Installation Update

This bulletin clarifies the installation protocol recommended by DiversiTech for condensate safety overflow switch CS1200.

Testing

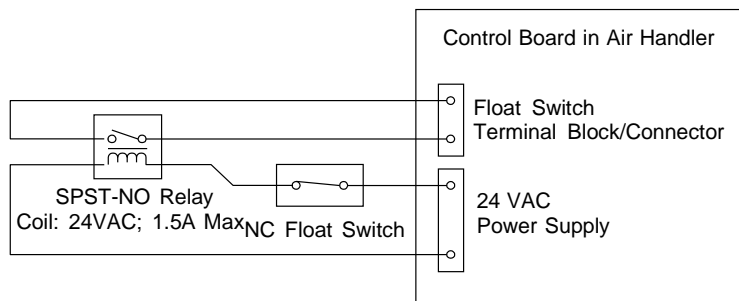
First, proper system shutdown verification testing is performed, ensuring that the system is running normally. Then, push the test button on the CS1200.

Finally, check that the system shuts down as expected. If the unit does not shutdown, it is sensitive to switch characteristics when compared to traditional systems and requires a relay. Please implement the relay solution outlined below.

Use a normally open SPST relay with a 24VAC coil (DiversiTech part # D90-290Q or equivalent) to break the condensate overflow safety shutdown input circuit. DiversiTech condensate switch CS1200 should be used to make or break control power to the relay coil.
